MILITARY SPECIFICATION

PUMP, SEA WATER

This amendment forms a part of MIlitary Specification MIL-P-82442(OS) dated 10 May 1966.

Figure 2, Seawater Pump Flow Diagram

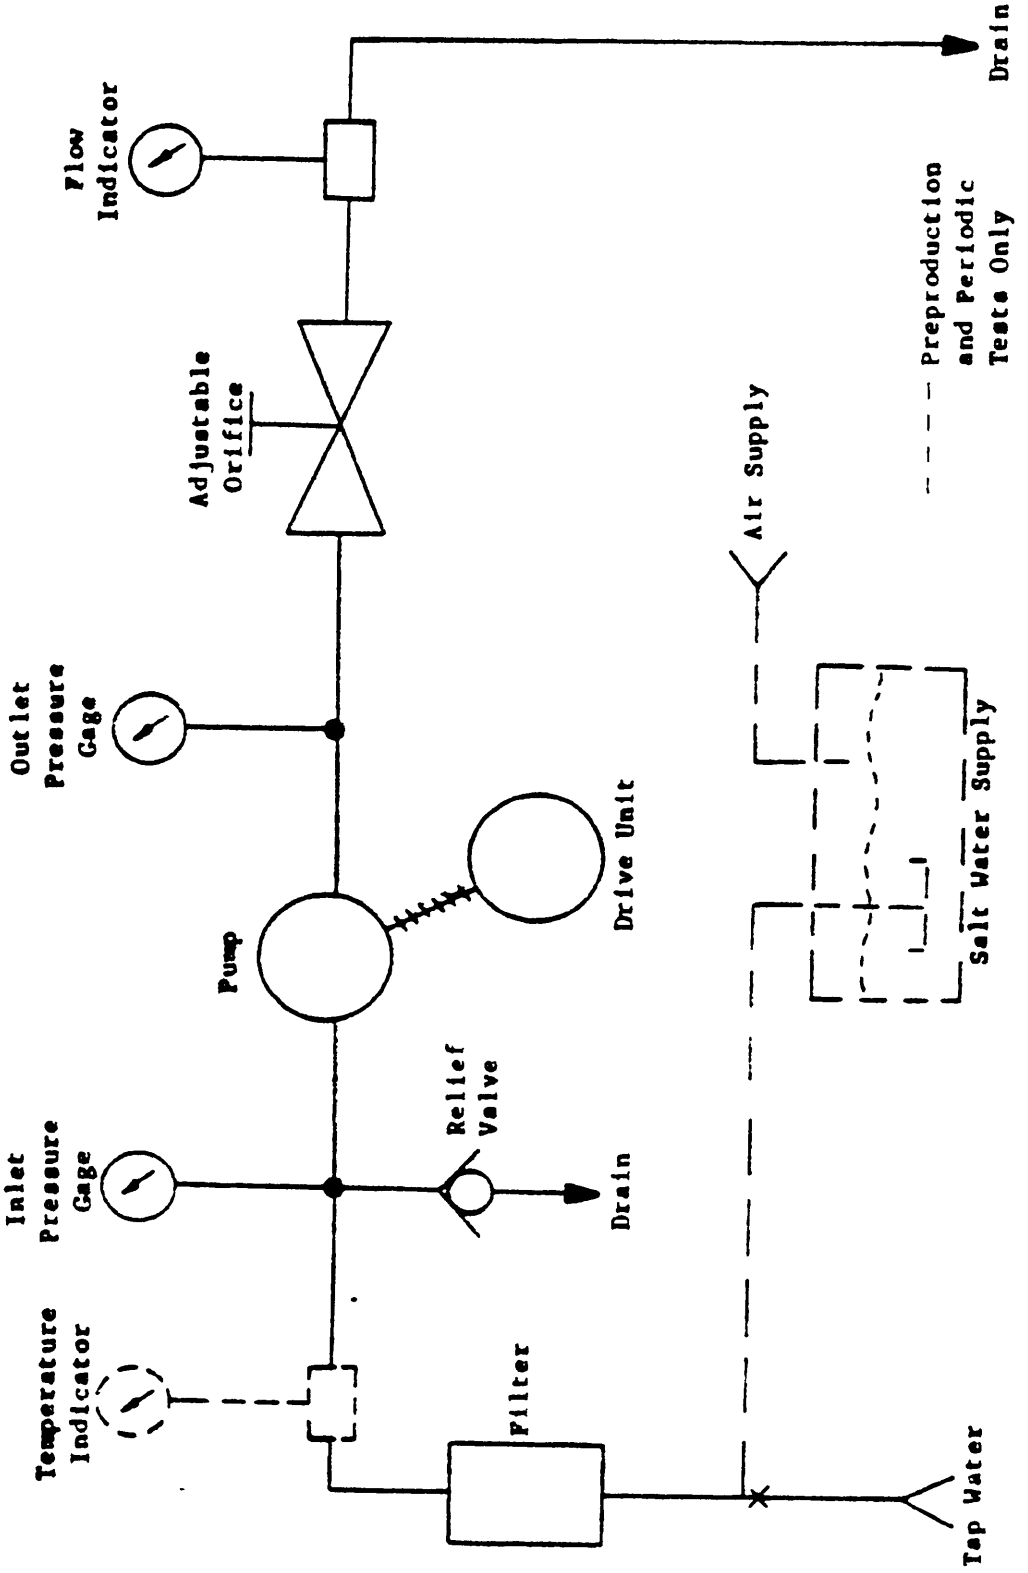
Paragraph 4.5.3, line 4: Delete "charcteristics indicated:" and substitute "characteristics indicated: (See Figure 2)". .

Paragraph 4.5.3 Add the following subsections:

Replete Figure 2 with new Figure 2, attached.

"(f) Pressure gage, inlet:

Range:	O to 25 psig
Accuracy:	±2% full" scale
Operating temperature	+25°F to +150°F minimum
Gage size:	6-inch minimum"

‘(9) Filter:

Element ;	50 microm maximum
Operating pressure	50 psig minimum
Flow capacity:	10 gpm minimum"

‘(h) Flow meter:

Range:	0 - 10 gpm, accuracy to ±2% full scale
Minimum operating temperature:	+25°F to +lOO°F"
